# Response to Submissions Documentation

## Waterloo South

Stockland and Homes NSW

Revision B

Solar access into George Street

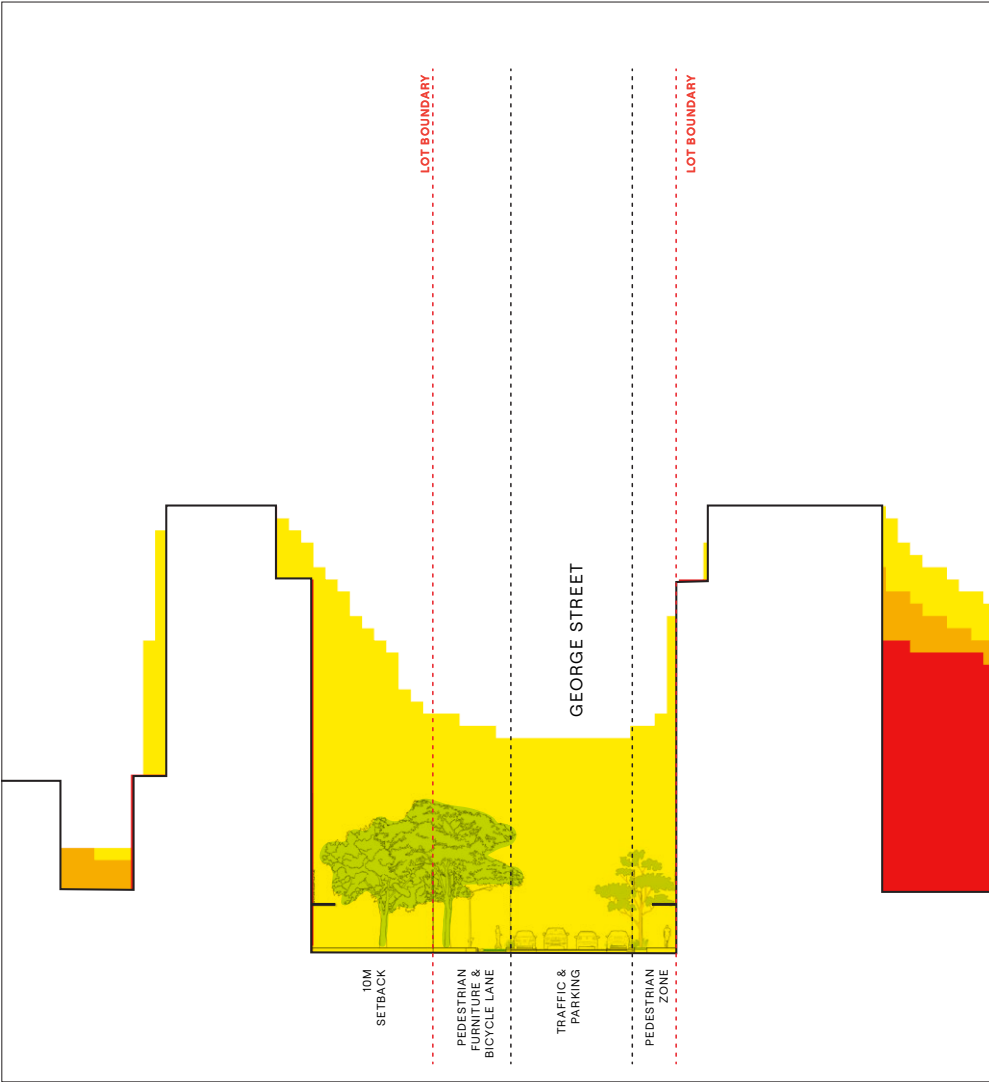
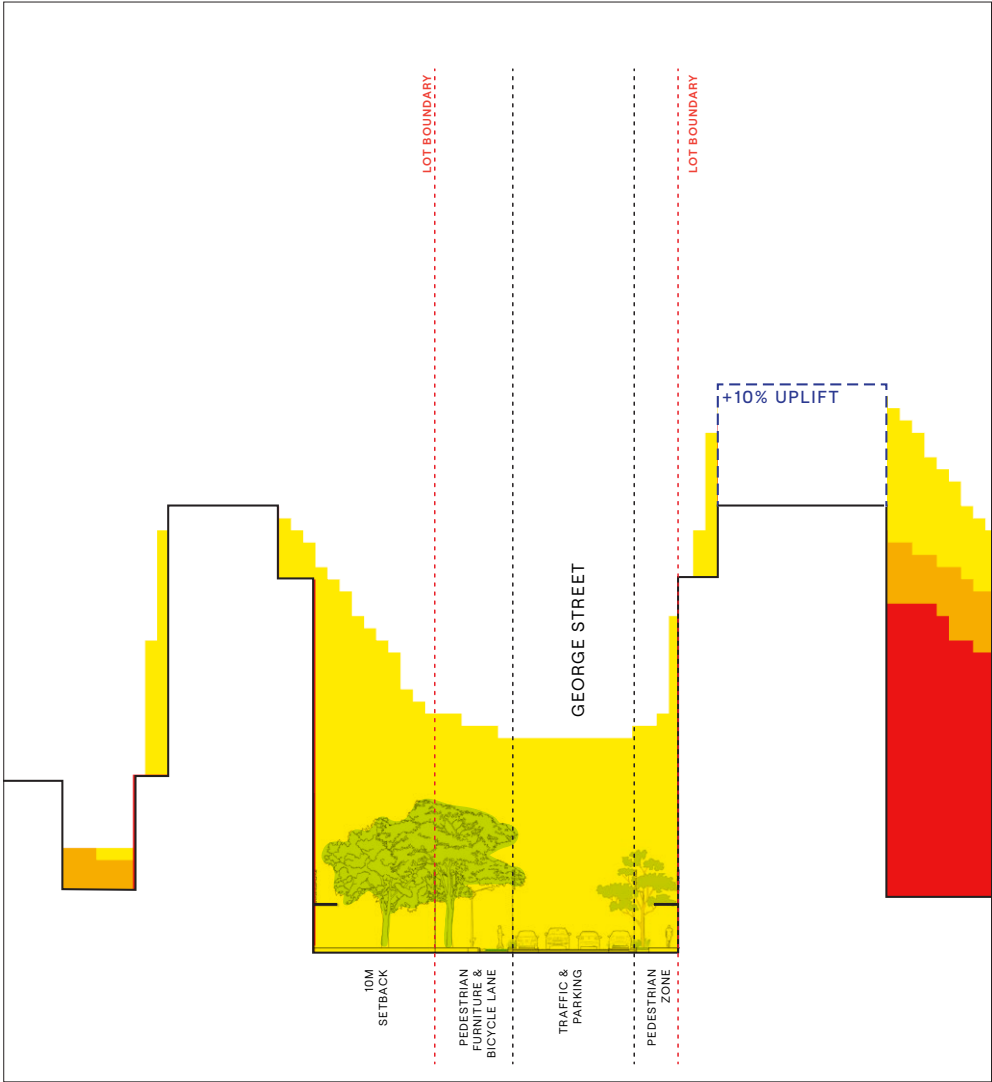
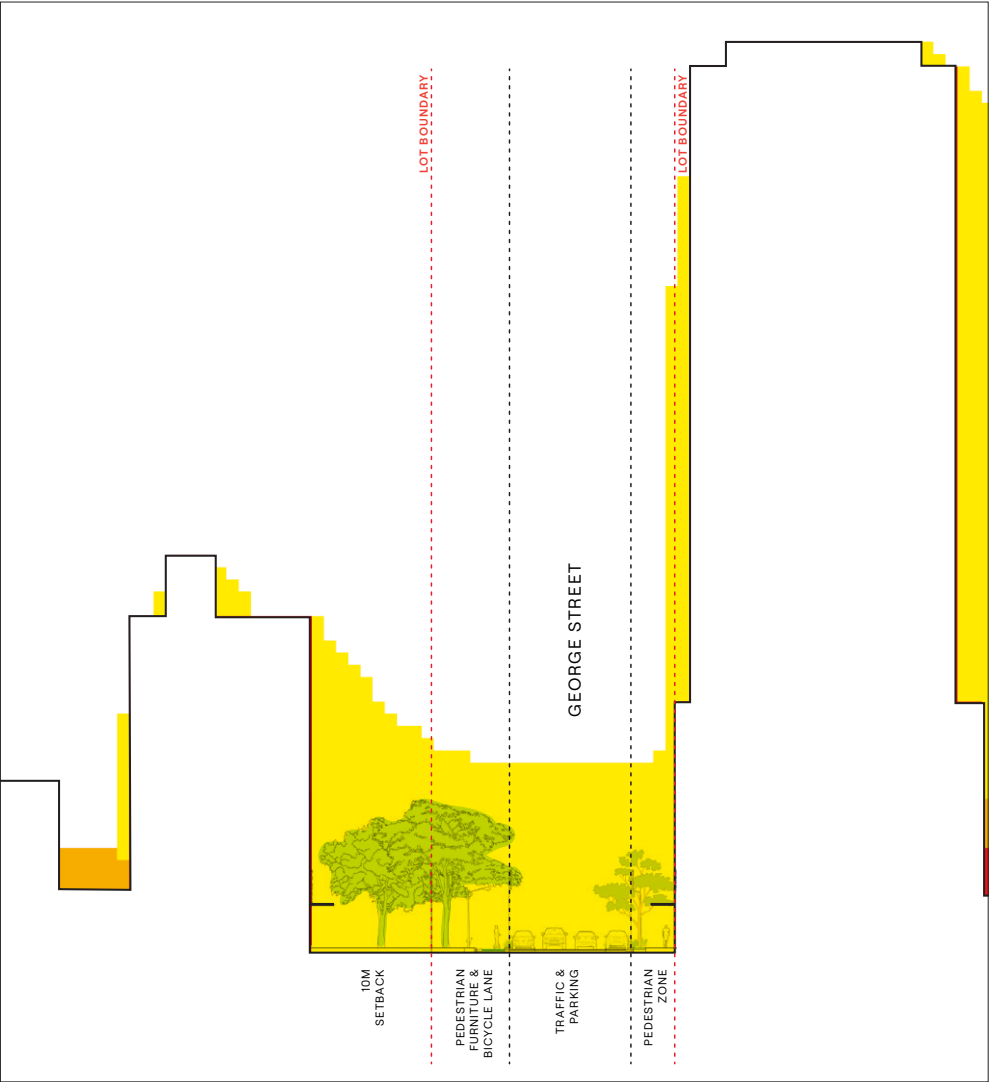
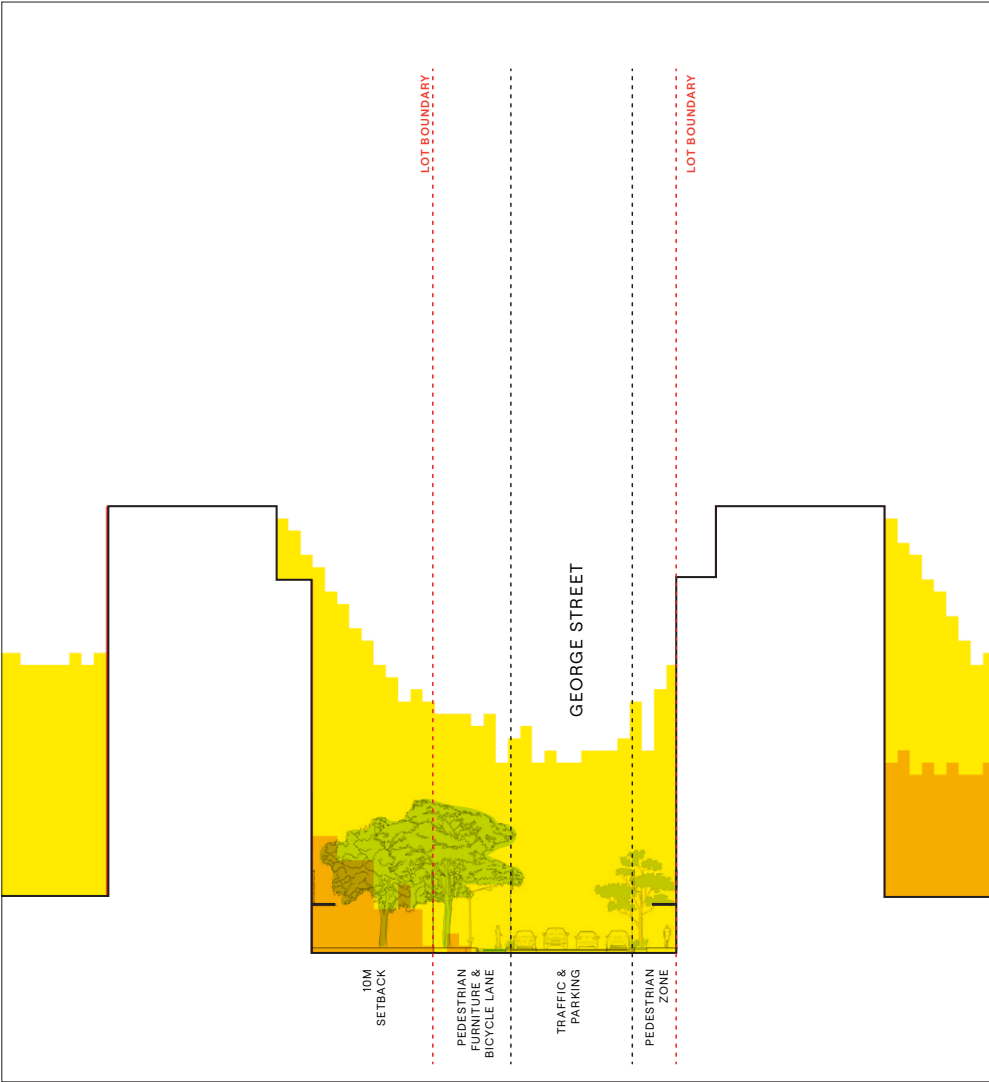
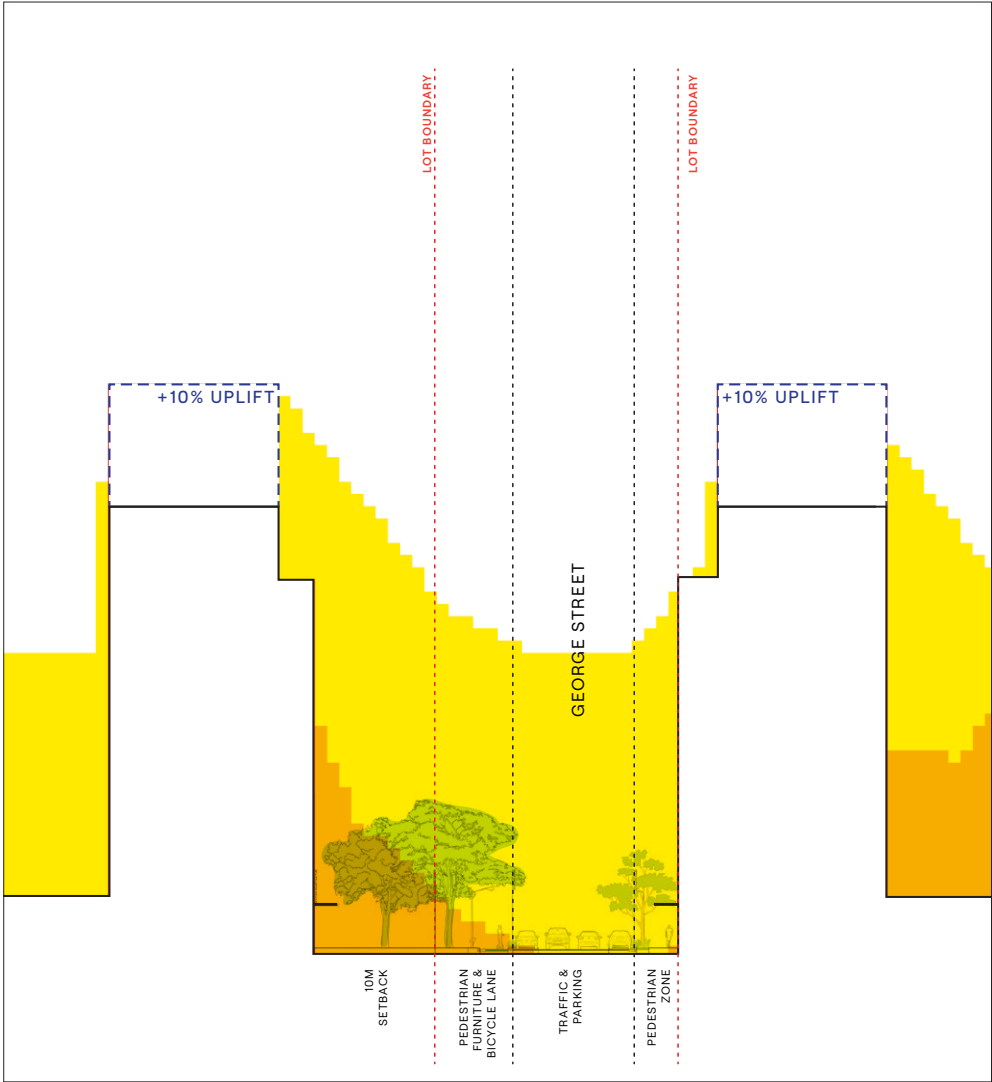
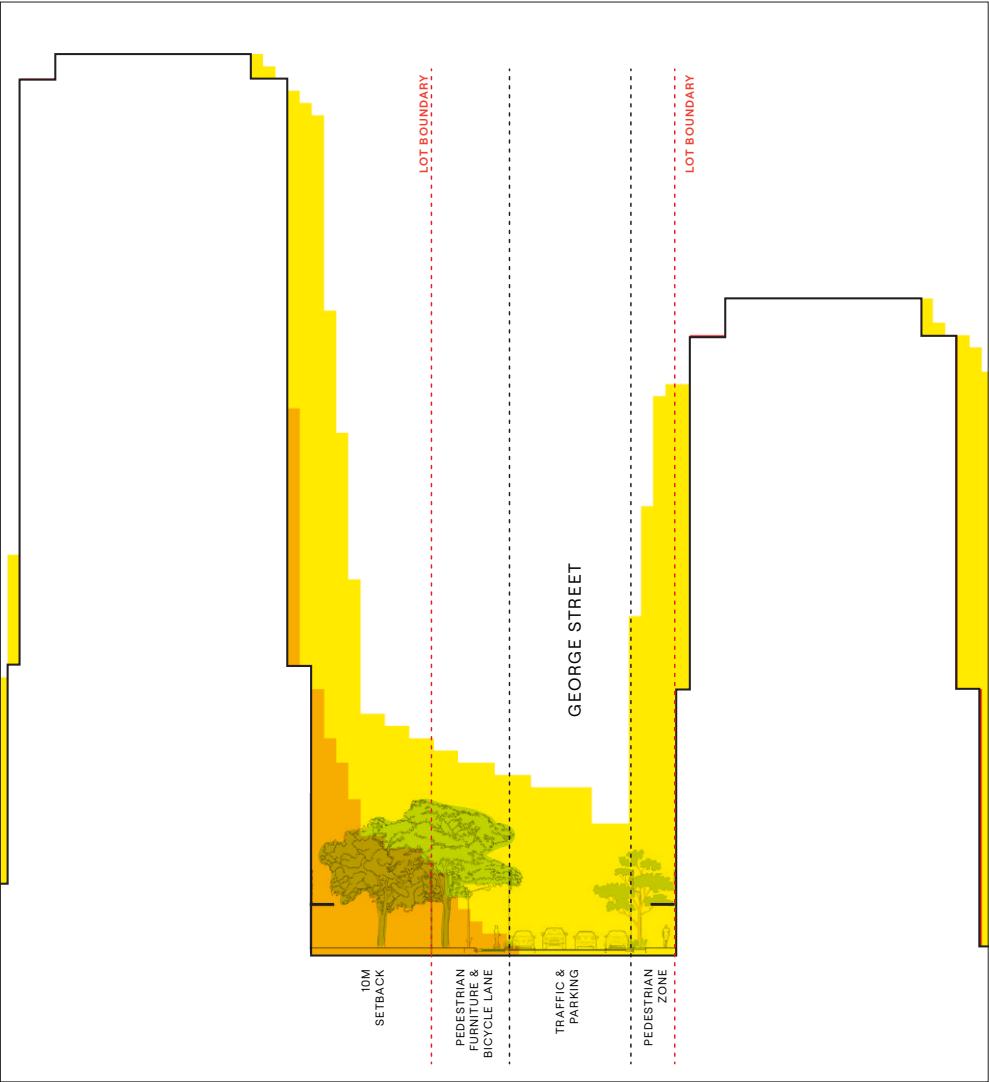
| Agency                                                  |  | Summary of Key Issues                                                                                                                                                                                                                                                                                                                                                                                                                                                                                                                                                                                                                                                                                                                                                                                                                                                                                                                                                                                                                                                                                                                                                                                                                                                                                                       | Response                                                                                                                                                                                                                                                                                                                                                                                                                                                                                                                                                                                                                                                                                                                                                                                                                                                                                                                                                                                                                                                                                                                                                                                                                                                                                                                                                                                                                                                                                                                                                                                                                                                            | Supporting RtS Documentation |
|---------------------------------------------------------|--|-----------------------------------------------------------------------------------------------------------------------------------------------------------------------------------------------------------------------------------------------------------------------------------------------------------------------------------------------------------------------------------------------------------------------------------------------------------------------------------------------------------------------------------------------------------------------------------------------------------------------------------------------------------------------------------------------------------------------------------------------------------------------------------------------------------------------------------------------------------------------------------------------------------------------------------------------------------------------------------------------------------------------------------------------------------------------------------------------------------------------------------------------------------------------------------------------------------------------------------------------------------------------------------------------------------------------------|---------------------------------------------------------------------------------------------------------------------------------------------------------------------------------------------------------------------------------------------------------------------------------------------------------------------------------------------------------------------------------------------------------------------------------------------------------------------------------------------------------------------------------------------------------------------------------------------------------------------------------------------------------------------------------------------------------------------------------------------------------------------------------------------------------------------------------------------------------------------------------------------------------------------------------------------------------------------------------------------------------------------------------------------------------------------------------------------------------------------------------------------------------------------------------------------------------------------------------------------------------------------------------------------------------------------------------------------------------------------------------------------------------------------------------------------------------------------------------------------------------------------------------------------------------------------------------------------------------------------------------------------------------------------|------------------------------|
| City of Sydney<br>Community                             |  | <p><u>Solar access and daylight to public spaces</u></p> <p>The proposed amended design redistributes solar access to public places which now reduces solar access to more important places including George Street, John Street and the new small park, which less important public places like Cooper Street and Pitt Street are provided with increased solar access. Similarly, the daylight (sky view) levels follow a similar pattern and results in a diminution of light in George Street, which is of particular concern.</p> <p>This is not supported and the built form should be modified to ensure that there is no reduction of solar or daylight access to George Street or park spaces relative to the current Design Guide.</p>                                                                                                                                                                                                                                                                                                                                                                                                                                                                                                                                                                            | <p>The proposed Master Plan strategically redistributes solar access to support the precinct’s most significant public spaces, movement corridors and community destinations, including the enhanced role of Cooper Street and new public open space connections. All major parks meet or exceed the Design Guide solar access benchmark, with Block 8 Park demonstrating a substantial improvement over the 2022 Design Guide. Where localised reductions occur, these reflect deliberate urban design trade-offs to achieve lower podium forms, improved building separation, enhanced permeability and stronger public domain outcomes. Comparative testing against the 2022 Design Guide and Design Guide +10% scenarios demonstrates that the proposed Master Plan generally performs similarly to, or better than, the equivalent development yield outcome across the public domain network.</p> <p>Refer to the supporting RtS documentation section for detailed solar access, Sky View Index and comparative environmental analysis.</p>                                                                                                                                                                                                                                                                                                                                                                                                                                                                                                                                                                                                                  | Pg 42 - 52                   |

SJB acknowledges the concerns regarding George Street, John Street and the new local park and has undertaken further detailed comparative testing in the following pages, including consideration of the contribution of existing mature street trees. The analysis compares the 2022 Design Guide, the Design Guide +10% scenario (representing an equivalent development yield of approximately 282,000sqm GFA), and the proposed Master Plan. The results demonstrate that the proposed Master Plan generally performs similarly to, or better than, the Design Guide +10% scenario across the public domain network.

It is also noted that both the Design Guide +10% scenario and the proposed Master Plan concentrate higher levels of direct sunlight within the northern portion of George Street, indicating that this outcome is principally driven by the broader built form arrangement to frame George Street. The solar access sections and comparative analysis contained in the following pages further demonstrate that the proposed Master Plan achieves a balanced and appropriate public domain outcome while supporting the broader urban design objectives of the precinct.
